**Pier 26 Upland Park Construction – Electrical Construction
Project/Contract #C4891-C
Addendum # 4
December 3, 2018**

(A) "1. C4891 –A-E Pier 26 Upland Park Construction" is amended to include the following drawing modifications:

(B) "4. C4981-C Electrical Construction – Specifications" is amended to include the following specification modifications:

DECK SUBSLAB LAYOUT & GRADING PLAN - PIER A

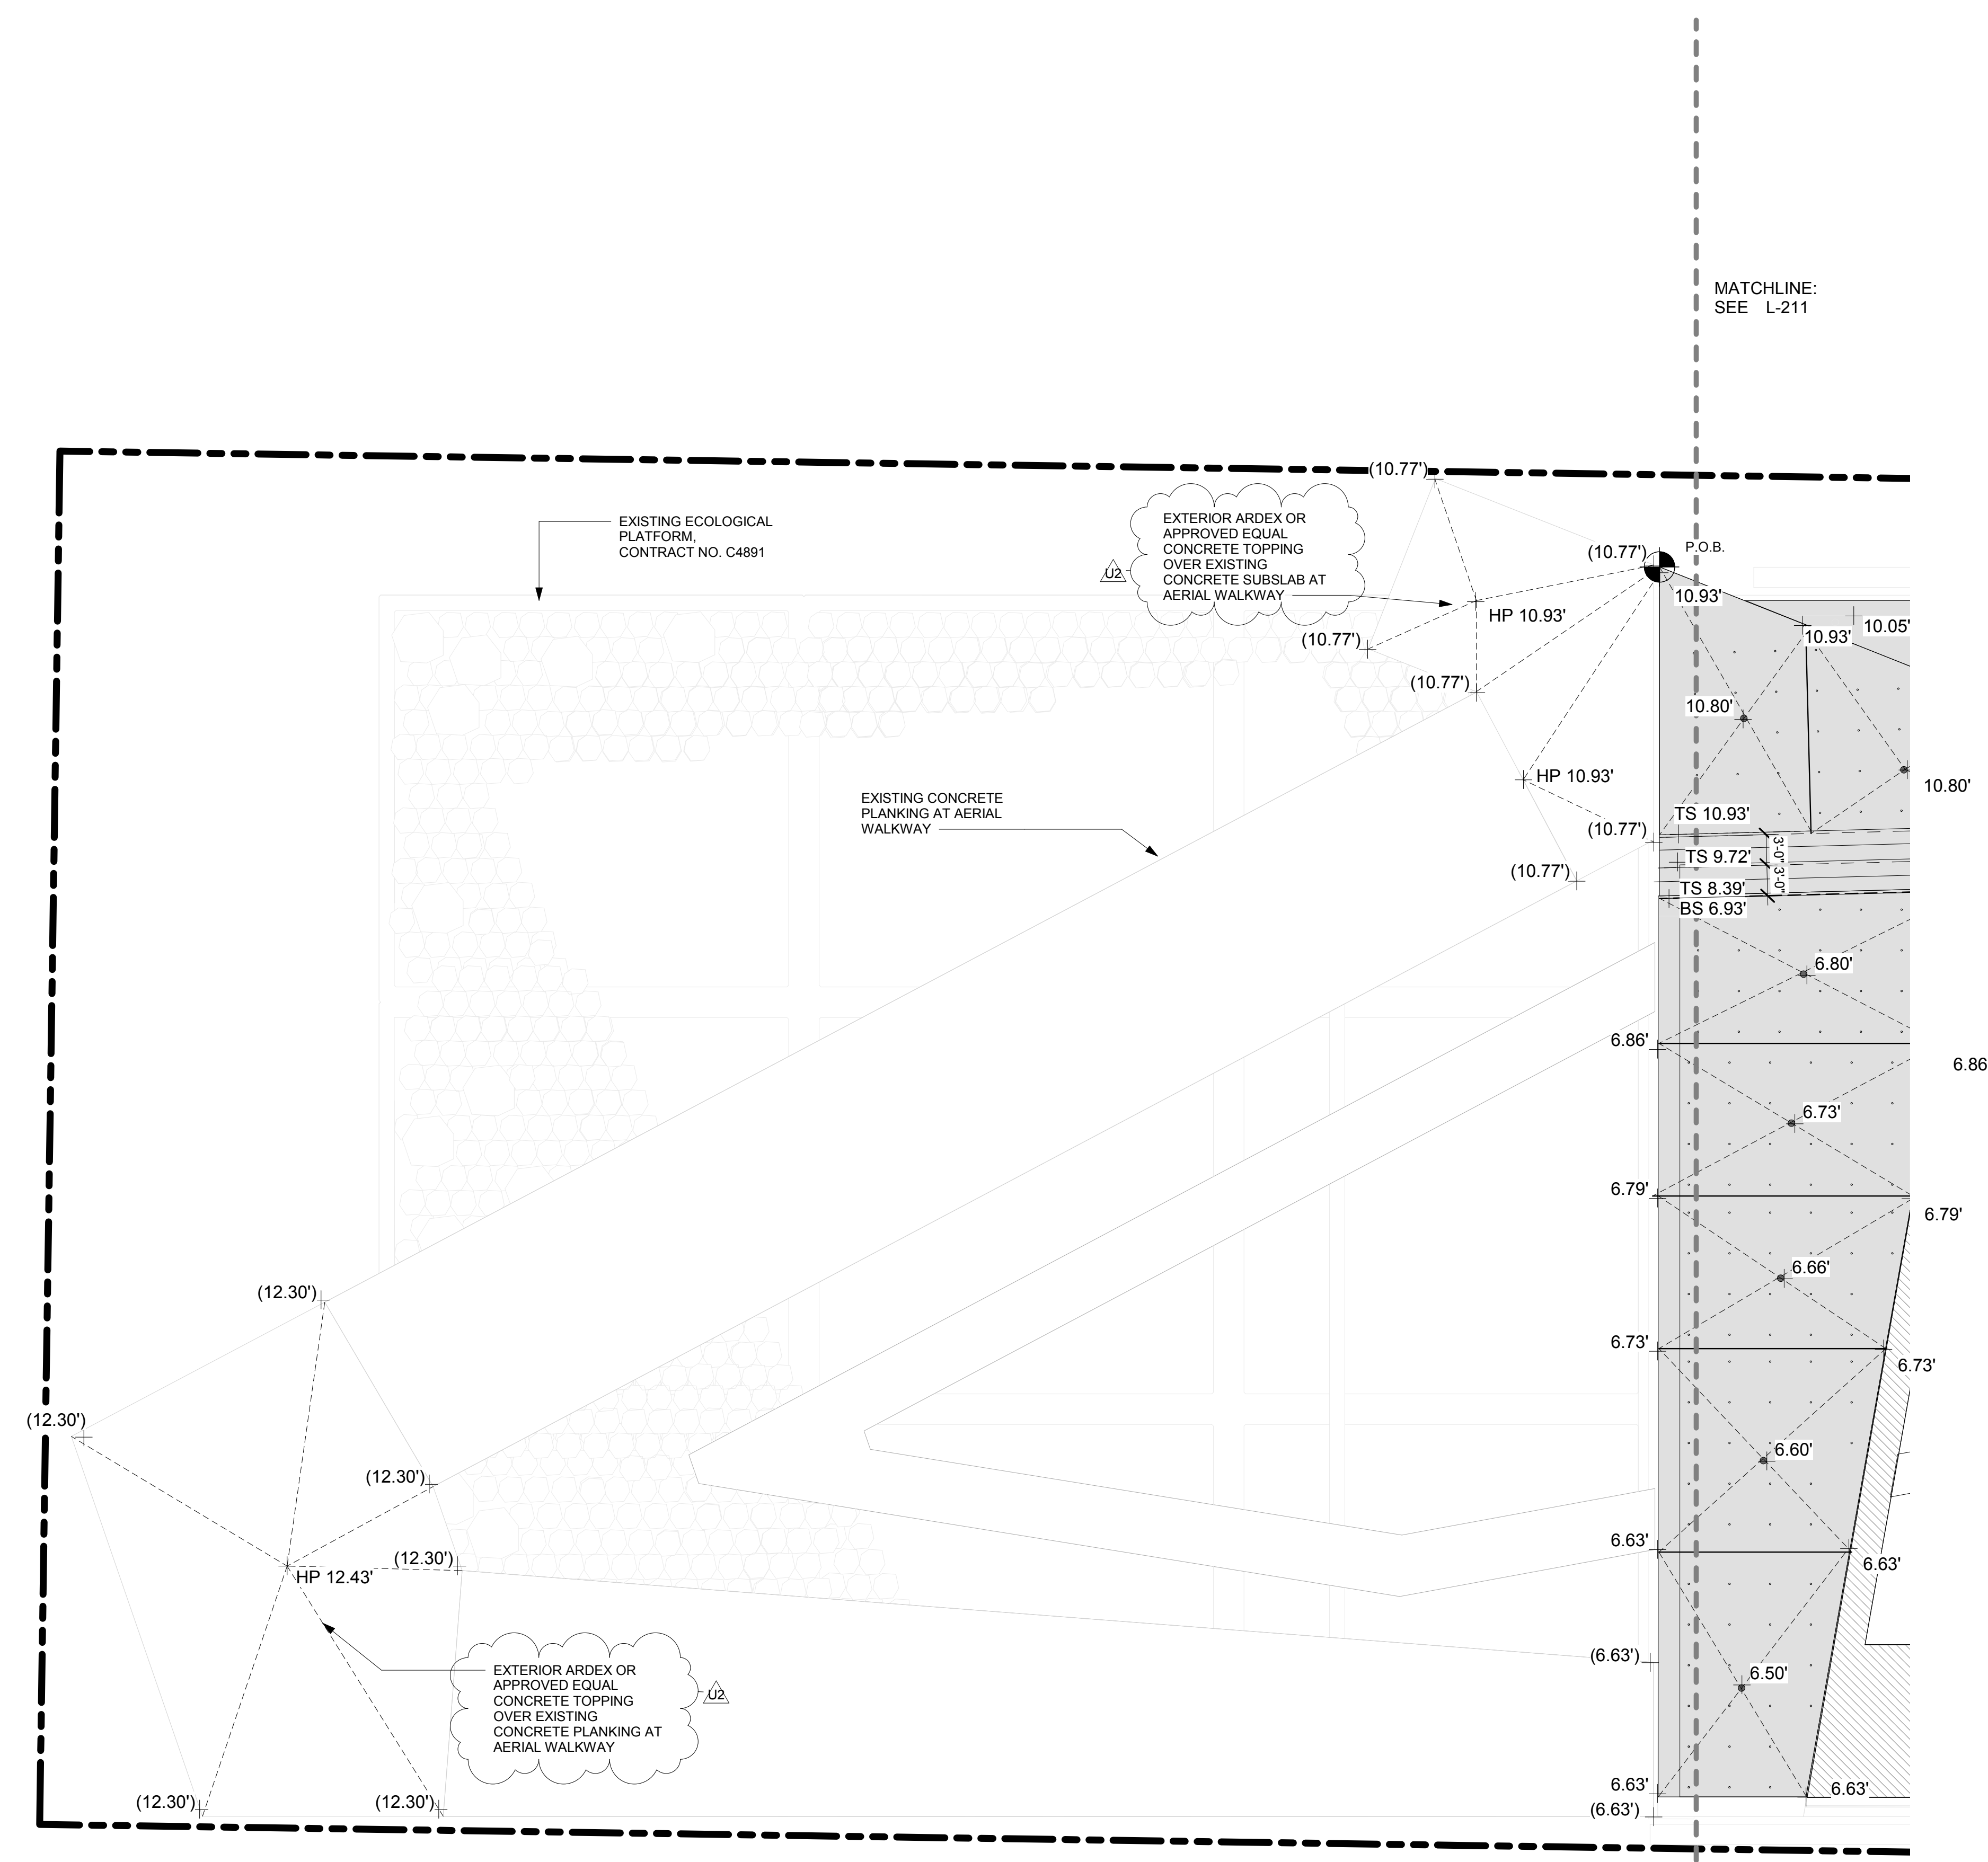
Drawing	Update
L-210-DECK SUBSLAB LAYOUT&GRADING PLAN - PIER A	Topping slab description clarified.
L-230-PAVING& DECKING PLAN- PIER A	Legend corrected to say inlaid finish, instead of sandblast inlaid finish.
L-231 - PAVING & DECKING PLAN - PIER B	Legend corrected to say inlaid finish, instead of sandblast inlaid finish.
L-232 - PAVING & DECKING PLAN - PIER C	Legend corrected to say inlaid finish, instead of sandblast inlaid finish.
L-233 - PAVING & DECKING PLAN - PIER D	Legend corrected to say inlaid finish, instead of sandblast inlaid finish.
L-234 - PAVING & DECKING PLAN - NORTH UPLAND	Legend corrected to say inlaid finish, instead of sandblast inlaid finish.
L-243 - PAVING MODULES	The unique shell inlay material has been removed.
L-400 - GRADING PLAN - PIER A	Symbol for slot drain and trench drain has increased visibility.
L-401 - GRADING PLAN - PIER B	Symbol for slot drain and trench drain has increased visibility.

GRADING PLAN - PIER C

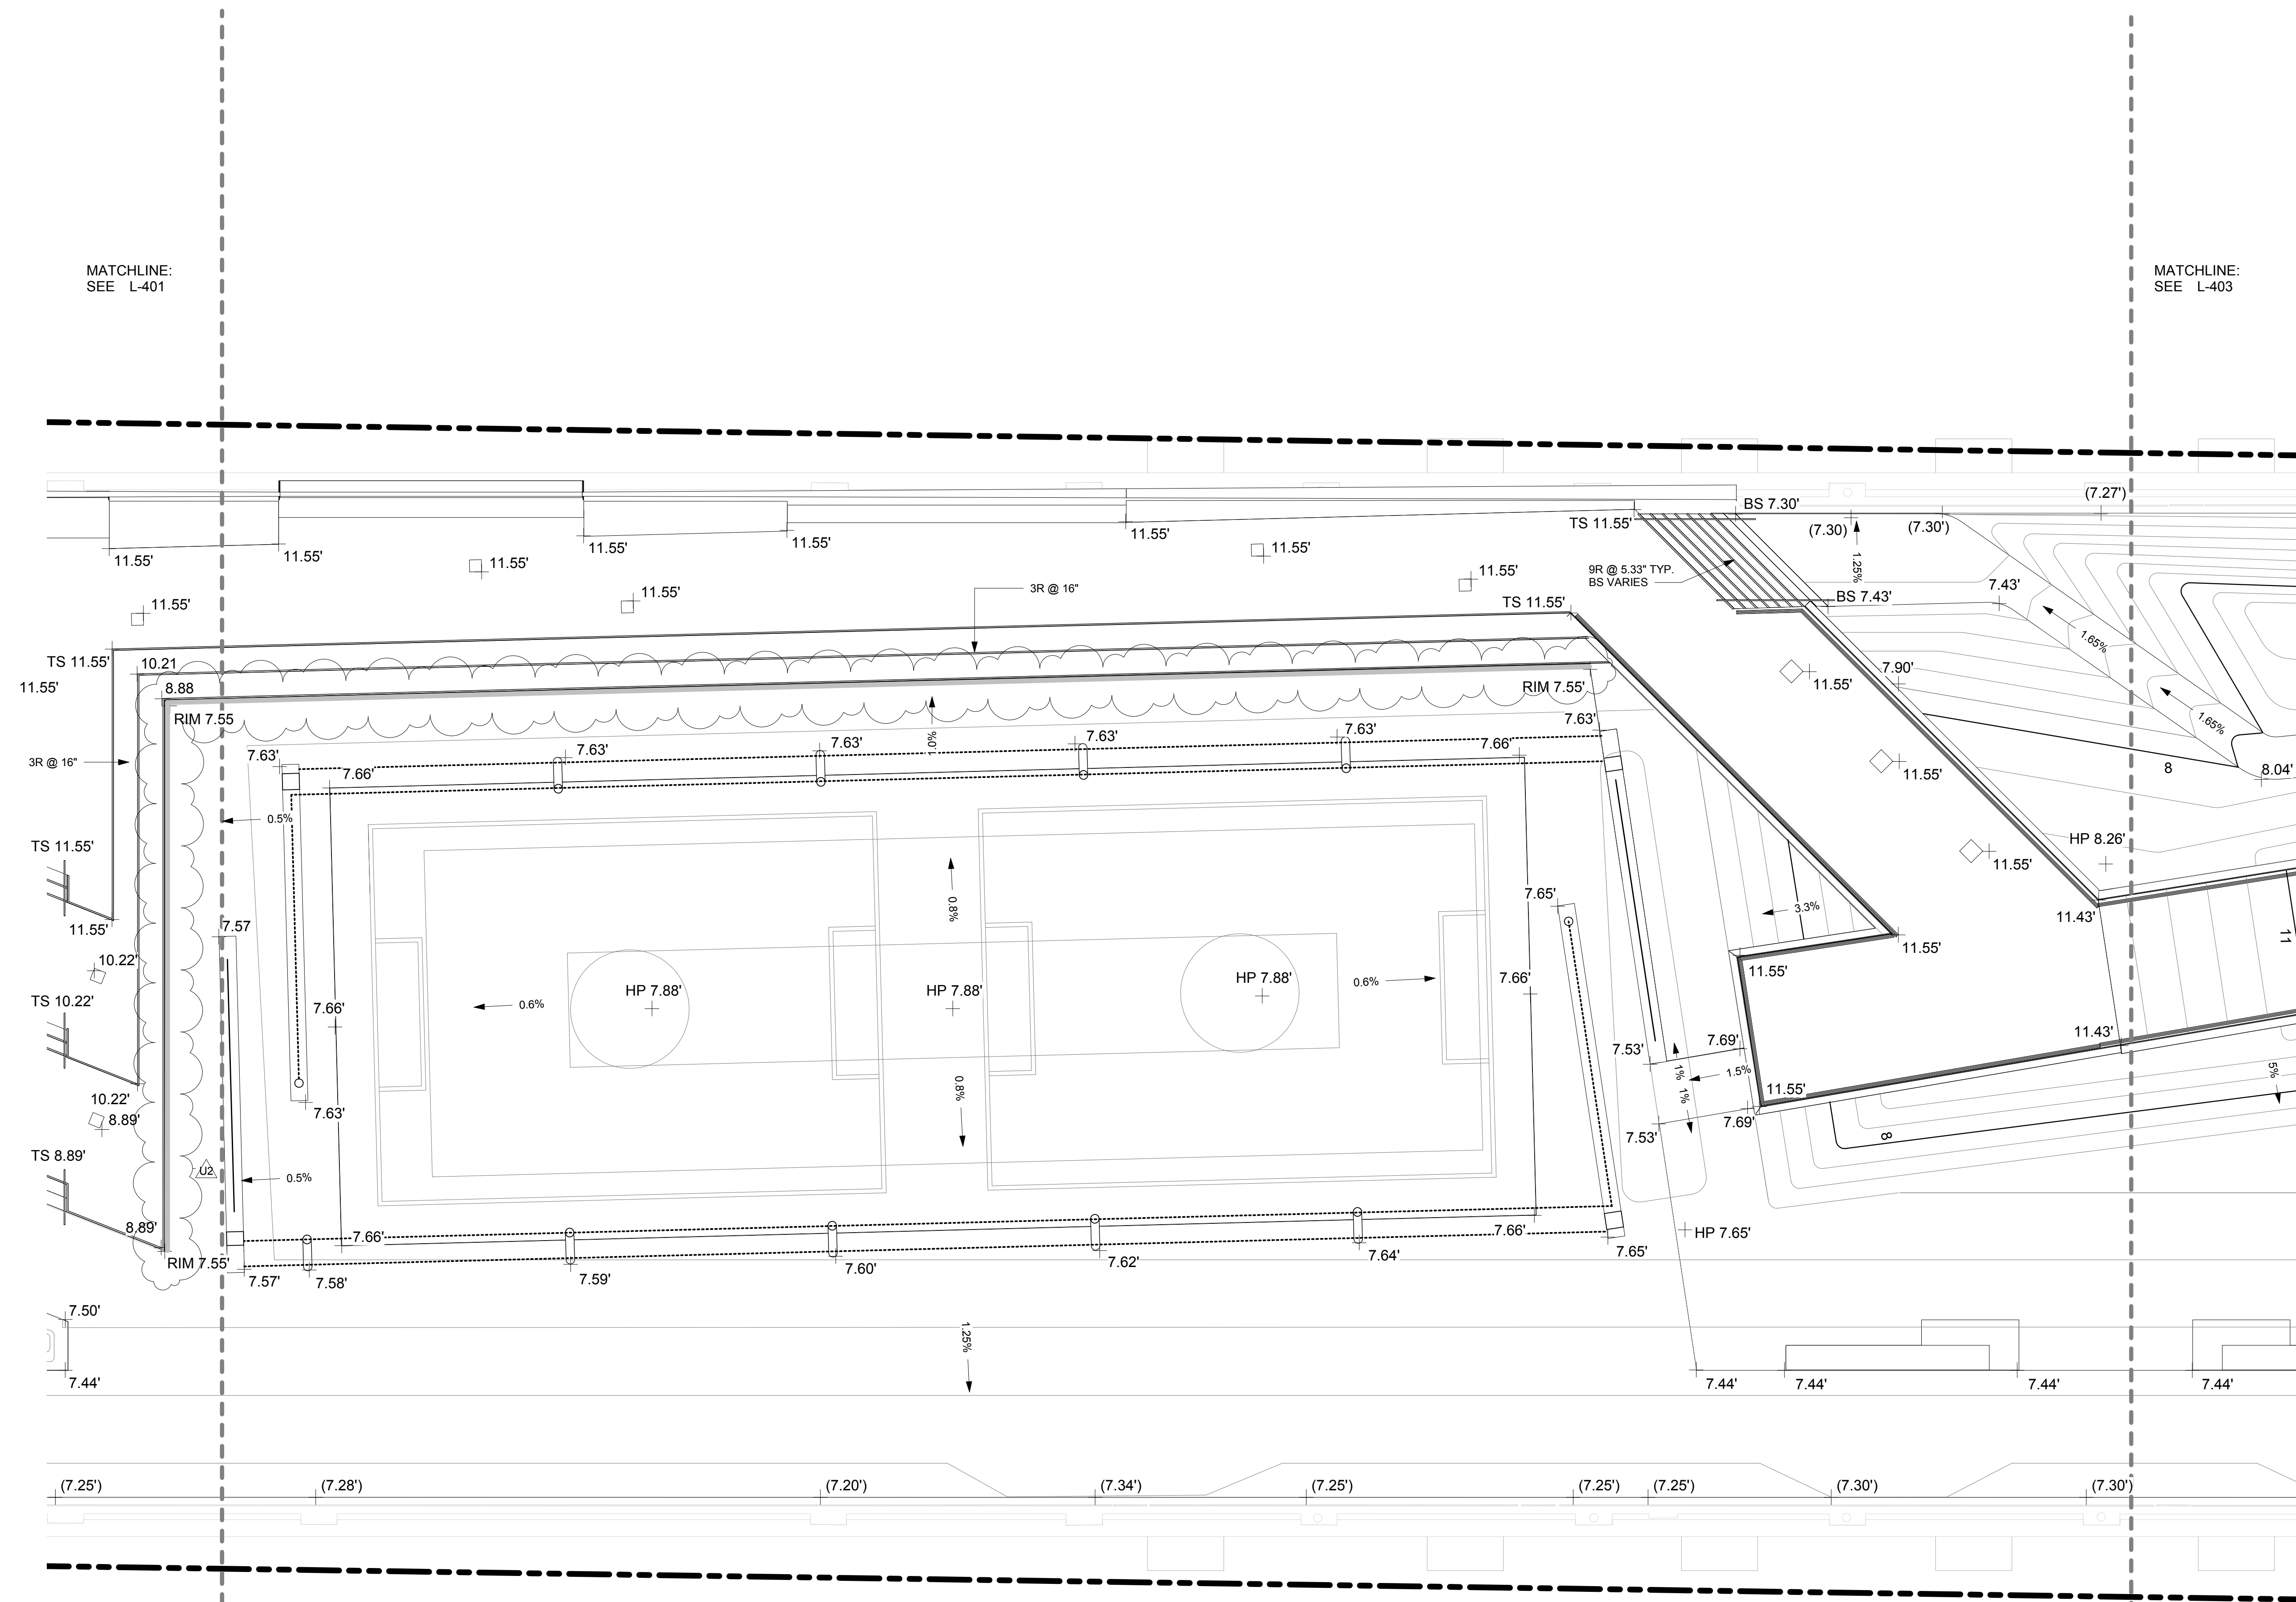
L-402 - GRADING PLAN - PIER C	Symbol for slot drain and trench drain has increased visibility.
L-403 - GRADING PLAN - PIER D	Symbol for slot drain and trench drain has increased visibility.
L-404 - GRADING PLAN - NORTH UPLAND	Symbol for slot drain and trench drain has increased visibility.
S-301 - FRAMING PLAN - PIER B	Walkway south of seating terrace no longer called out as 8" concrete seating step.
S-302 - FRAMING PLAN - PIER C	The thickness of the concrete is correctly labeled to show the 8" depth only at the 15' wide southern, as in the materials plans.
E-301 - ELECTRICAL PLAN - PIER B	Location of Q-vault shown.
E-302-ELECTRICAL PLAN - PIER C	Electrical clarification to sport pole.
E-308 - WOOD AND STEEL SHED ELECTRICAL DETAILS.pdf	New sheet showing clarifications of electrical work at the sheds.
P-303 - SANITARY PIPING PLAN - PIER D	Cross section of piping added.
P-312 - SANITARY PIPING PLAN - PIER C	Clarification to boat service utilities.
